DOCKET 50-255 - LICENSE DPR-20 - NUREG-0737 - UPDATE - PALISADES PLANT

Consumers Power Company's letter dated December 19, 1980 provided our response to the items of NUREG-0737 for the Palisades Plant. Since that submittal, it has become necessary to update our response as follows:

PALISADES PLANT

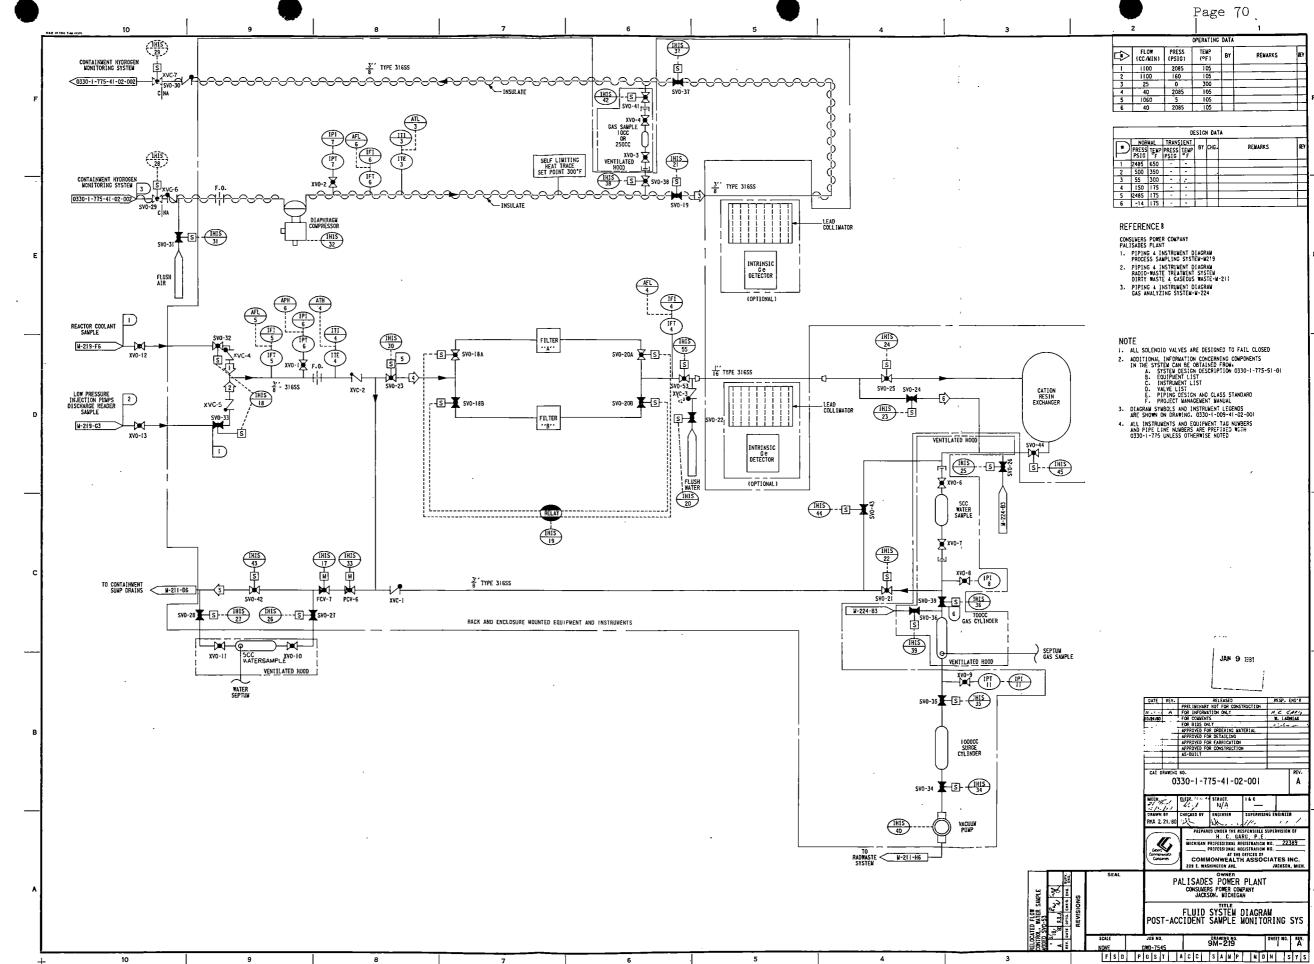
Figure 1, Page 70 of our December 19, 1980 response is no longer correct. The correct figure of the Post-Accident Sampling System is attached (Page 70, Rev 1).
